PREVOST

**WARRANTY
 BULLETIN**

WB12-08

DATE : APRIL 2012	SECTION : 01 - Engine
EXPIRATION: APRIL 2014	
SUBJECT : A/C COMPRESSOR BELT- IDLER PULLEY ADDITION

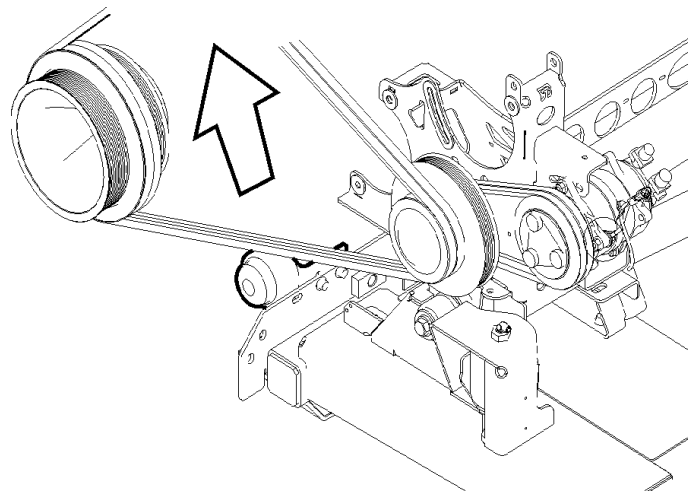
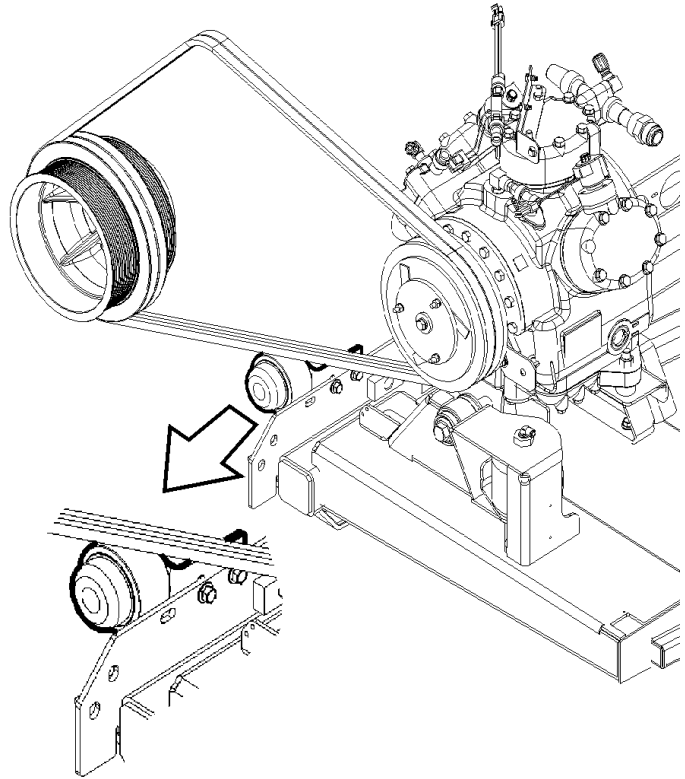
On the vehicles affected by this bulletin, the addition of an idler pulley is recommended to prevent A/C belt slapping and vibration. This addition will also prevent the belt from slipping off the pulley grooves.

Select idler pulley assembly according to your vehicle.

- #457506 for X3-45 and X3 VIP
- #457509 for H3-45 and H3 VIP

Idler pulley assembly is the same with large or small compressors.

1. Install idler pulley assembly with specified M10 hardware. Hand-tighten only.
2. Adjust pulley/belt gap between 0 and 1/16".

Gap is measured with tightened belt.

3. Tighten M10 mounting bolts to 32 lb.-ft.
